The authors would like to thank the reviewers for their time, and valuable comments. The comments of both reviewers are useful as they improve the quality of the paper. The comments of each reviewer are addressed separately. The explanation for each question/comment is marked in blue while the actual changes in the manuscript are marked in red.

## Reviewer 1

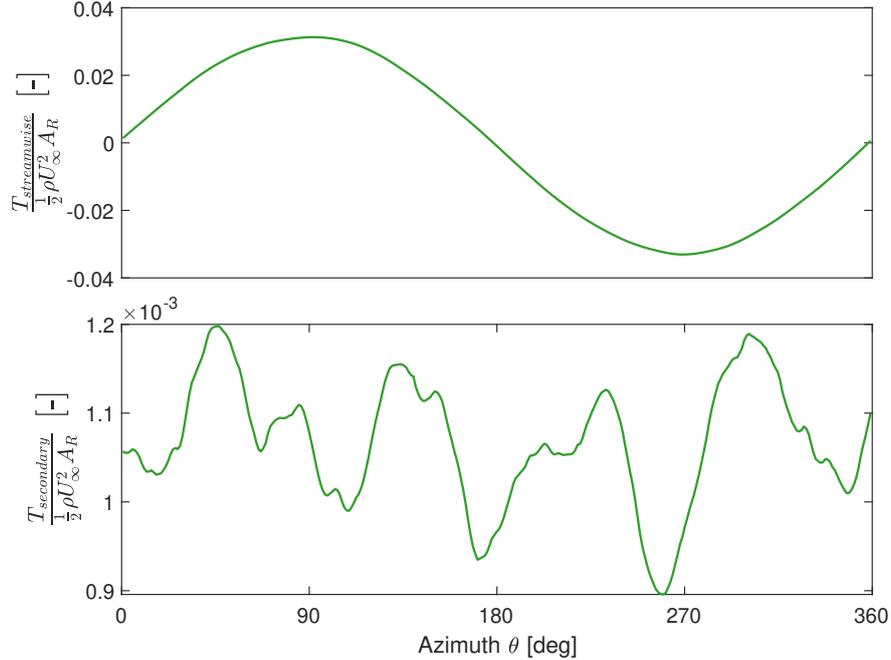
*PFLOW simulation includes the secondary rotors. The size of the secondary rotor should be stated in the paper. In addition, it is better that information, such as the rotational speed of the secondary rotor blades and its thrust force (drag force) in the PFLOW calculation, is described in the paper. The reviewer suspects that the aerodynamic loss of the entire X-Rotor may be quite large, because the secondary rotors generate power and the propeller blades generate large drag.*

We have now added additional information about the secondary rotor in *Appendix C: PowerFLOW Setup* as we believe adding secondary rotor specification and its thrust data to the results section would clutter the main findings of the paper. The normal and tangential loads shown in the paper are only the loads of the primary rotor blades. The lower blade loads from PFLOW simulations in Figure 9 are lesser than the other models in the upwind due to the forcefield created by the secondary rotors. The design of the secondary rotors is to balance the torque on the primary rotor, which should not create huge losses in power as suspected by Reviewer 1. Further information about this is included in the paper. Line 21 has been edited to help clarify the purpose of the secondary rotors in the X-Rotor concept as: **Rather than removing power from the main shaft of the primary rotor, the rotor speed is controlled by the thrust force on the secondary rotors, and all electrical power is extracted from the secondary rotors.** A thrust profile of the secondary rotor in its azimuthal cycle from PFLOW is also added to *Appendix C*. The force has been non-dimensioned using the same constant for the primary rotor forces. The magnitudes that can be observed show that the influence of thrust on the primary rotor blades is very minimal, owing to also what is explained previously. The following content has been added to *Appendix C: PowerFLOW Setup*:

**The simulations conducted are of the primary rotor coupled with the secondary rotor and the tower. The dimensions and the operating condition of the secondary rotor is mentioned in Table TABLE. Additionally, the thrust profile for one of the two secondary rotors for the last revolution from the PFLOW calculations is provided in Figure 1.**

Figure 2: Inflow angle at 50% span, nondimensional torque and thrust of the upper blade at  $\beta = -10^\circ$

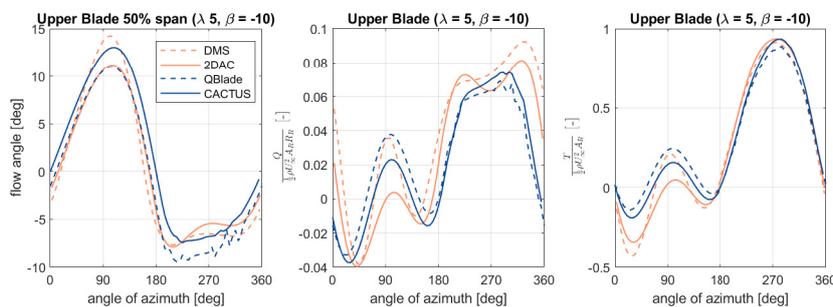
*line 189-190: In DMS, when the pitch angle  $\beta$  becomes negative, the  $C_p$  increases, unlike other models. The authors think this can be attributed to the assumption of DMS in which the downstream actuator is placed in the upwind actuator's completely expanded (decelerated) flow field. The reviewer would like to request the authors to show and compare the flow field in the mid of the rotor between different models. The velocity distribution of DMS which will be compared can be the completely expanded flow speed after the upwind half.*

The authors agree with the reviewer that the paper would benefit from a further explanation of the breakdown of the DMS method. However, as the velocity field is not well defined at the mid-point of the rotor in the DMS method, the authors believe that flow field visualisation at the rotor mid-point may not be the best means of comparing the methods. We believe comparing the thrust and torque of the negative pitch case can give some insights that can explain this anomaly. In the DMS method, the flow retardation is under predicted in the downwind rotor section leading to a larger (in absolute terms) flow angles, shown in Figure 2. This is compounded by the negative thrust values in the upwind rotor section accelerating the flow, also shown in figure Figure 2. The increased flow angle leads to an increased angle of attack in downwind rotor section and increases the torque production. Additionally, through ignoring the effect of the downwind actuator surface on the upwind actuator, a larger inflow angle is also predicted in the upwind rotor portion. This leads to a positive angle of attack in the upwind section (with the inflow angle larger than 10 degrees) and positive torque production in the upwind rotor section which is not predicted by the 2D actuator cylinder model. Secondly, exaggerated streamtube expansion/contraction is demonstrated by the size of the region in which the flow angle is positive, also shown in Figure 2. This increases the size of the downwind rotor section and the range over which positive torque is produced, increasing the power coefficient estimate. The opposite occurs at positive pitch offsets, where the region in which positive torque production occurs (the upwind rotor section) is contracted. This effect explains the drastic drop in power observed at  $\beta \geq 5^\circ$ . The text from line 190 is revised to read: **There are two key features which lead the**

breakdown of the DMS method in situations with pitch offsets. Firstly the DMS method does not consider the induction of the downwind portion of the rotor at the upwind actuator surface which becomes more critical as the loading is skewed to the downwind section at negative pitch offsets. Additionally, the streamtube expansion correction used in the DMS model over-predicts the contraction at the upwind actuator surface and the expansion at the downwind actuator surface. This leads to the region over which negative torque is produced to be contracted and the region over which the positive torque is produced to be extended leading to an over-prediction in power production in the case of negative pitch offsets. The Section 3.1.2 is also altered to reflect this detail that was left out in the previous version of the paper: The DMS model under predicts the thrust values at high loading, indicating that the correction used for high blockage cases is inaccurate. Additionally, the dependence on pitch angle does not agree with the other models. This can again be attributed to the effects of on over prediction of streamtube expansion increasing the estimate of thrust as the loading is shifted to the downwind rotor half, and decreasing the estimate of thrust as the loading is redistributed to the upwind rotor half in a similar manner to the power as discussed in section Section 3.1.1.

Figure 3: Azimuthal discretization sensitivity study conducted for QBlade for 4 different discretization levels. Y axis on the left shows mean  $C_p$  of last revolution from QBlade and the axis on the right shows the percentage error with respect to the power at 144 discretizations.

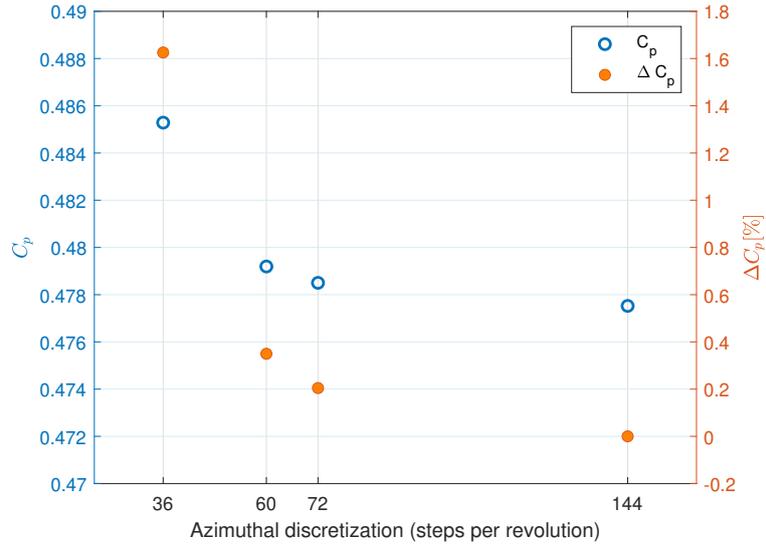
line 156: 72 azimuthal discretizations per rotation big; QBlade can be sensitive to this. Did the authors consider other discretizations?

Yes. We performed a sensitivity study between 4 different azimuthal discretizations: 36, 60, 72, and 144 in QBlade (to get  $10^\circ$ ,  $6^\circ$ ,  $5^\circ$ , and  $2.5^\circ$  per time-step respectively) for  $C_p$  convergence. We have attached the sensitivity results below (Figure 3). We found that between 72 and 144, there was only a 0.2% difference in  $C_p$ , which was considerably small. As the trend shows, finer discretizations would yield less error. However, the 144 discretization case took nearly 3 times longer than the 72 discretizations case. Furthermore, we wanted consistency between the vortex models (with the number of vortex filaments, the time-step size and the blade section discretizations) as well as the DMS and 2DAC models. Due to these factors, we chose 72 discretizations for all our simulations.
